Response 2 from National Grid Electricity Transmission plc (NGET) to Ofgem's consultation (dated 17 November 2023) on the Draft Determination on the North Wessex Downs Visual Impact Mitigation Reopener. This follows on from NGET's initial response dated 15 December 2023.

As part of NGET's initial consultation response discussions, Ofgem agreed that it would supply evidence of where the 7.5% cap on risk had originated from. Once Ofgem supplied this evidence, Ofgem agreed that an additional response could be provided on the subject. On 6 February 2024, Ofgem supplied a spreadsheet called: 'Analysis_Risk_allowance_as_percent_of_other_direct_cost_allowance'. Ofgem has given NGET until 9 February 2024 to further respond. This second response is therefore focusing on risk.

Figure 1. Spread of allowed risk making up Ofgem's 7.5% cap

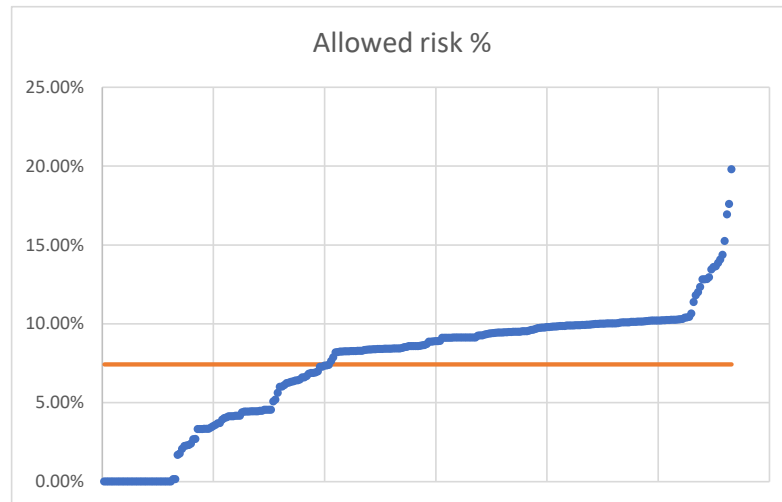
It is mathematically wrong to use an average as a maximum because it will systematically result in the allowances being lower than Ofgem's assessed efficient level. To illustrate this point, NGET have used the spreadsheet provided by Ofgem titled 'Analysis_Risk_allowance_as_percent_of_other_direct_cost_allowance' to complete our own analysis of the data. It can be seen from Figure 1 that the allowed risk across all 283 projects ranged from 0% to just under 20%:

The average of the above is 7.43%. By taking this percentage and using it as a maximum allowed percentage (as a cap), as though the above population of projects were being considered as re-openers, the average allowed risk would then be 5.95% (i.e. less than the level that Ofgem has defined as efficient). This is illustrated in Figure 2:

Figure 2. Effect of capping risk at an average

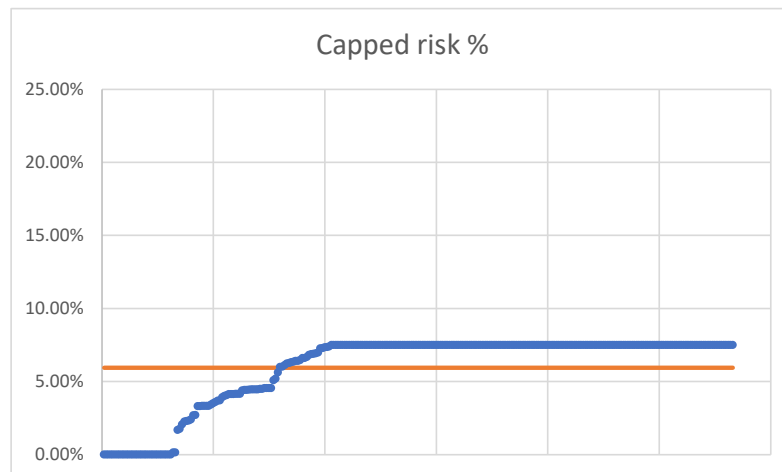
It does not matter what numbers are used, nor the number or type of projects; this will always be the case mathematically.

Figure 3. Effect of removing low outliers (i.e. those with <0.5% risk)

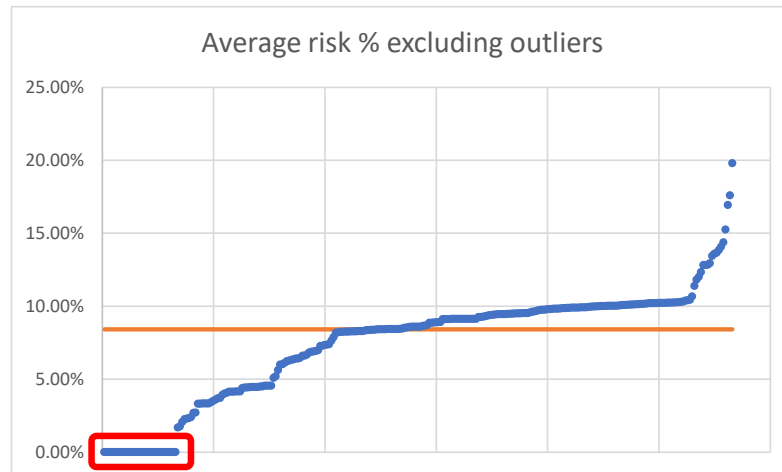
Looking at Figure 1, it can be seen that a number of data rows have zero risk. From what we can piece together from publicly-available information, the data rows with zero risk are not projects that construct assets. The majority are provisions for pre-construction, plus there are rows of forecast spend for 'Servitudes', 'Community Fund T2' and 'Injurious affection'; they are 'non-asset' spend. These are therefore outliers not relevant to an assessment of project risk and should be excluded from the calculation. Removing all data rows with less than 0.5% risk (circled in red below) as outliers results in an average risk percentage of 8.4%:
